MEETING OF JULY 7, 2020

SUBJECT: **SIP 19-6931: Site Improvement Plan (SW OF CLEBURN ST. & N. COLLEGE AVE./BEACON BLOCK APTS., 445-446):** Submitted by BATES & ASSOCIATES, INC. for properties located SW OF CLEBURN ST & N. COLLEGE AVE. The properties are zoned CS, COMMUNITY SERVICES and contain 2 parcels with approximately 0.64 acres. The request is for mixed use development with approximately 15,000 square feet of commercial space and 24 residential units with associated parking.

Re: Site Improvement Plan Approval: SIP 19-6931 (Beacon Block Apts.)

SUBJECT: Planning Commission Engineering Comments for VAR 19-6961 SW of Cleburn St. & N. College Ave (Beacon Block Apartments)

**EAST ELEVATION - BUILDING A
BEACON BLOCK**

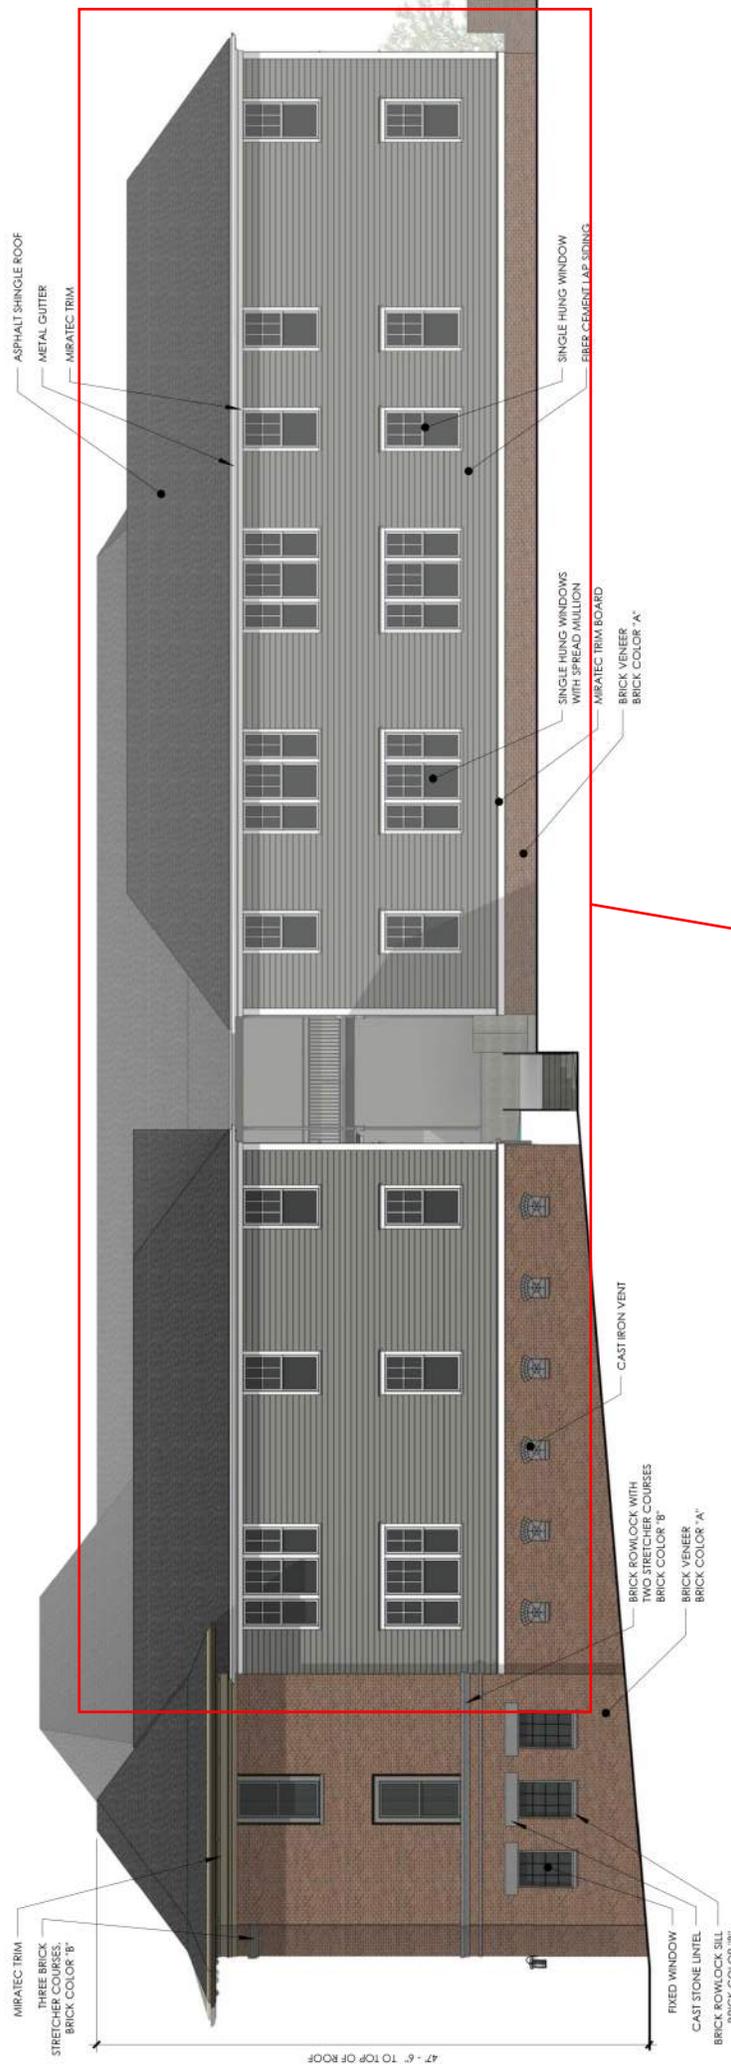
2 horizontal shifts in wall plane, materials, or texture required

Glazing does not meet 50% minimum

2 horizontal shifts in wall plane, materials, or texture required

**WEST ELEVATION
BEACON BLOCK**

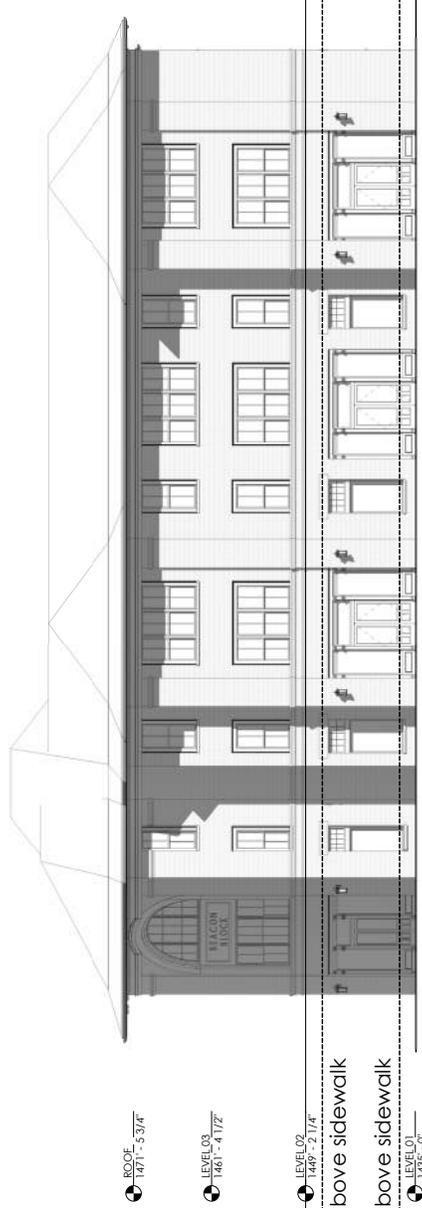
**Relief, Articulation,
and Architectural
Elements Required**

VAR 19-6961
Street
Section

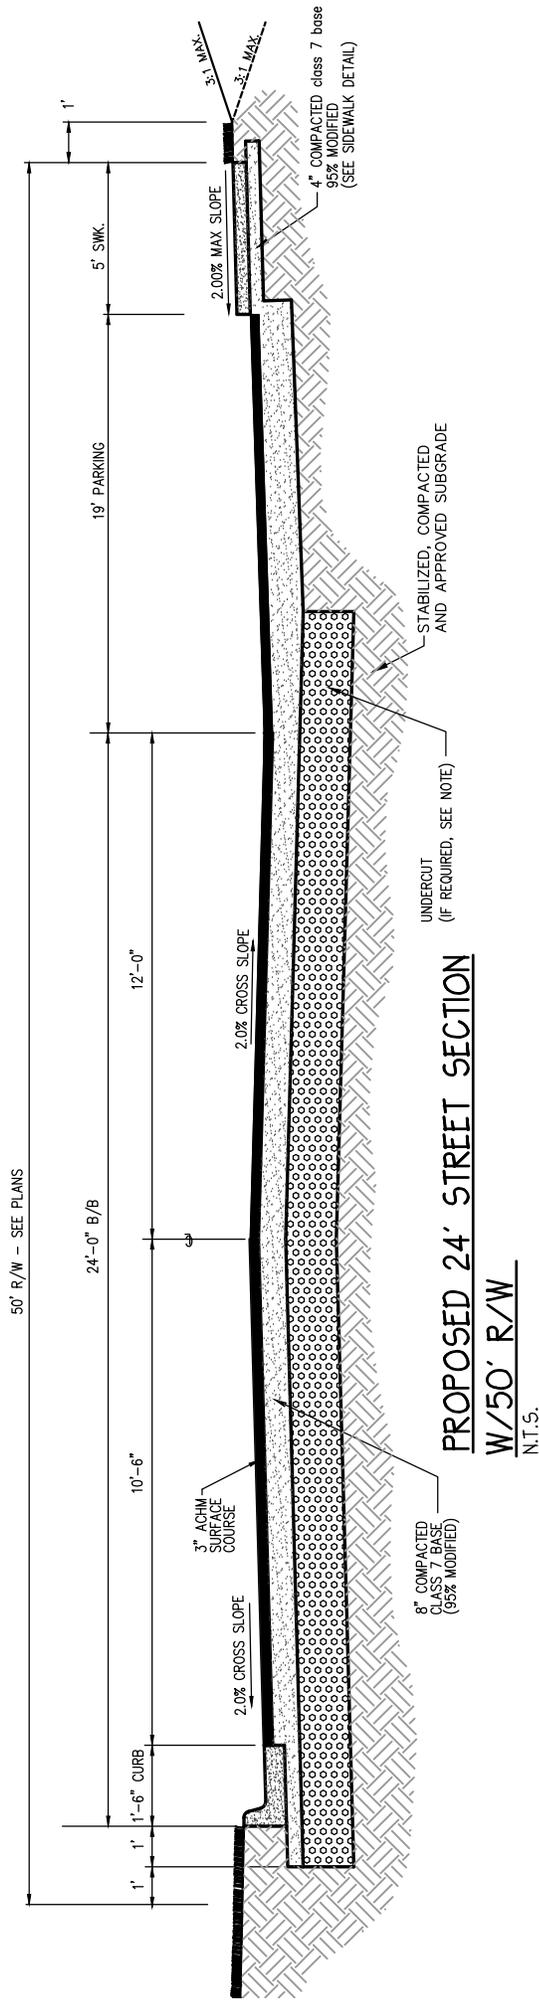
Engineering Comment / Response: Engineering is in support of a variance from the standard street section. However, the 5' sidewalk shown adjacent to 90 degree parking will not be sufficient. Engineering recommends a minimum 8ft of sidewalk with street tree's and tree wells.

This is the view from the stop sign heading south on Pollard at Cleburn

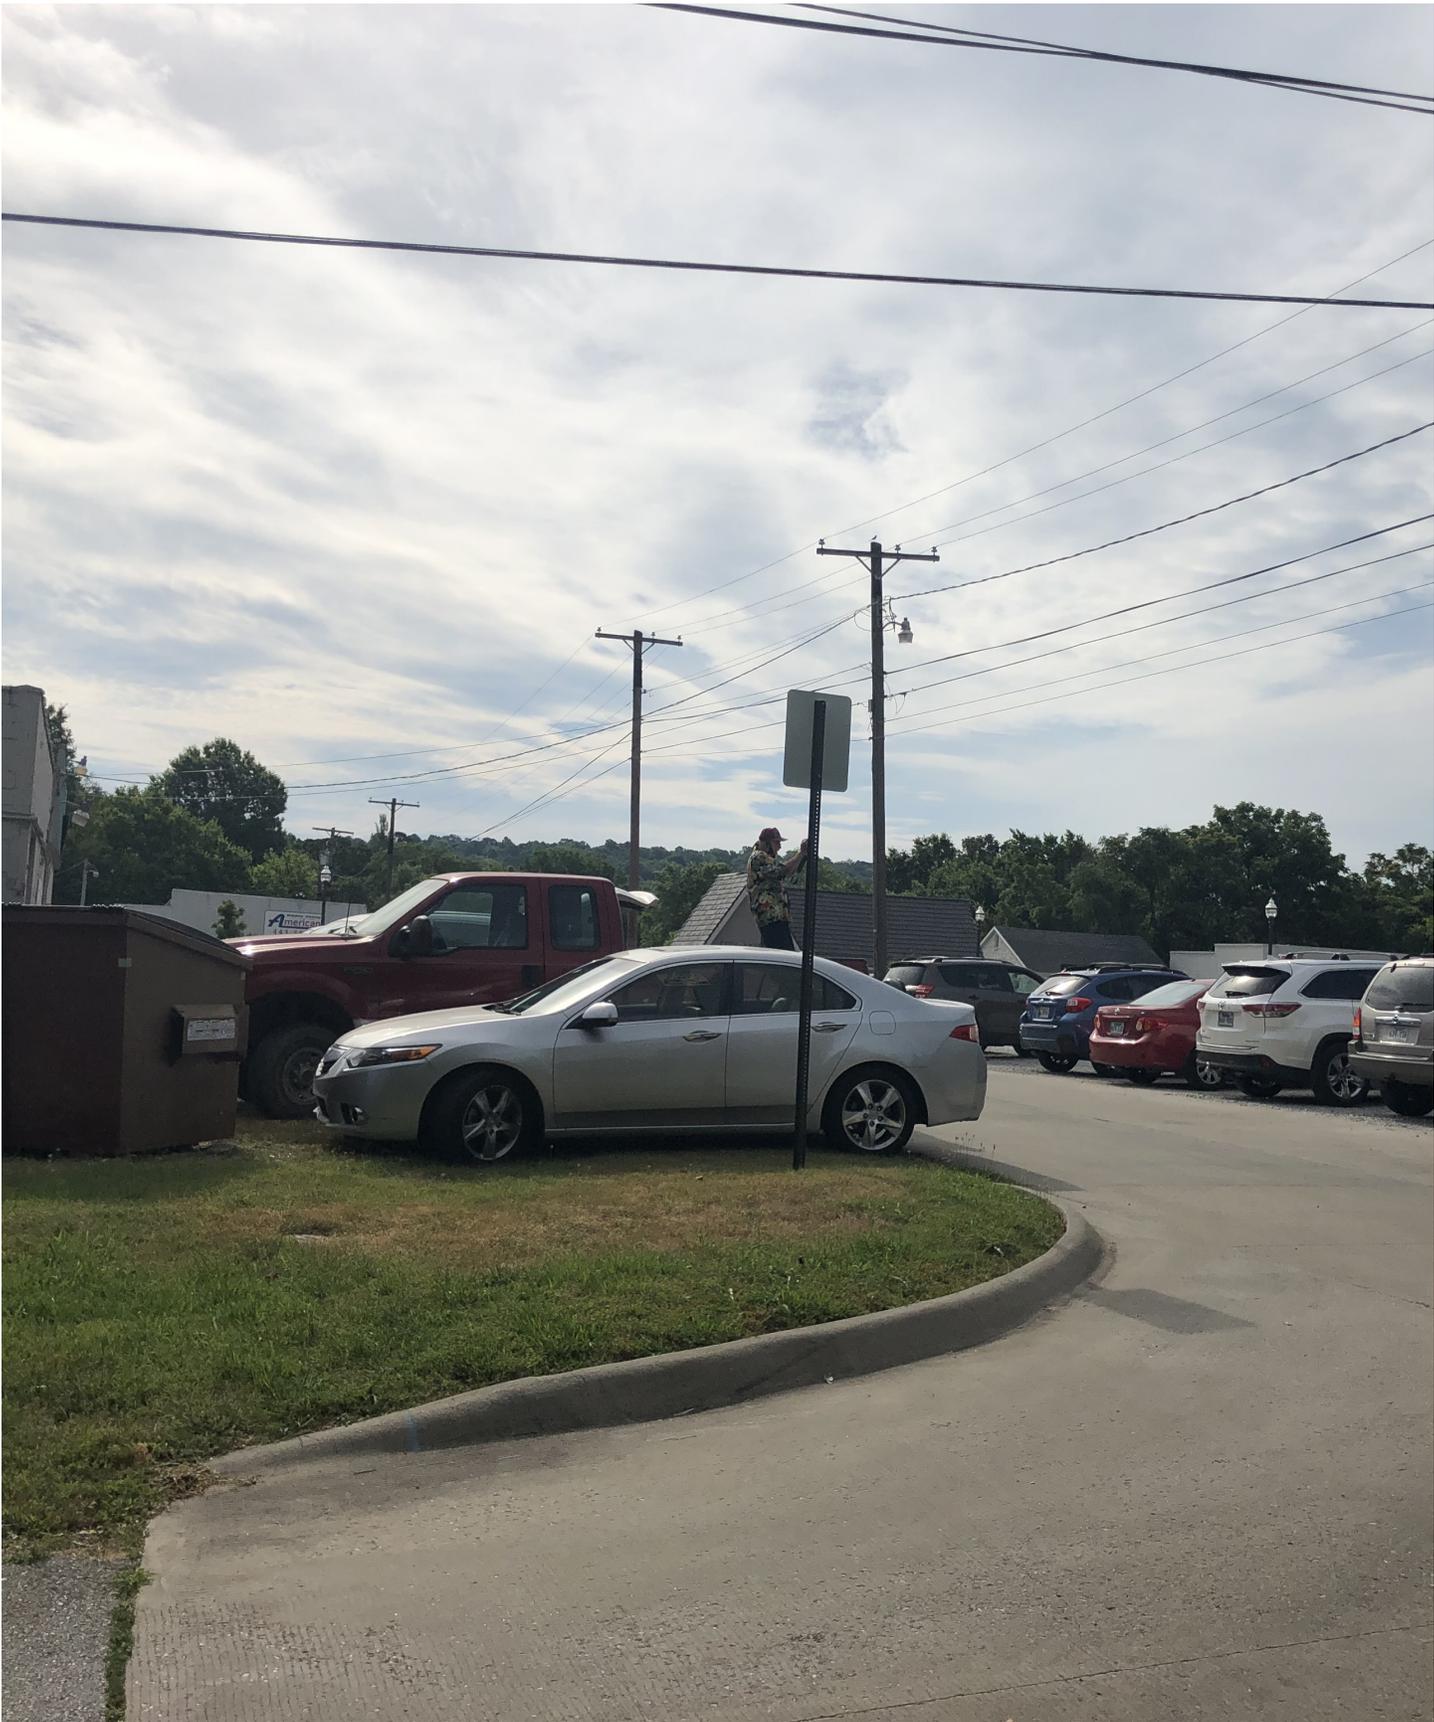
Following the UDC this situation should not be allowed due to it compounding a dangerous traffic situation and creating a dangerous traffic situation.

Please review these pictures and feel free to contact me if you wish to discuss them.
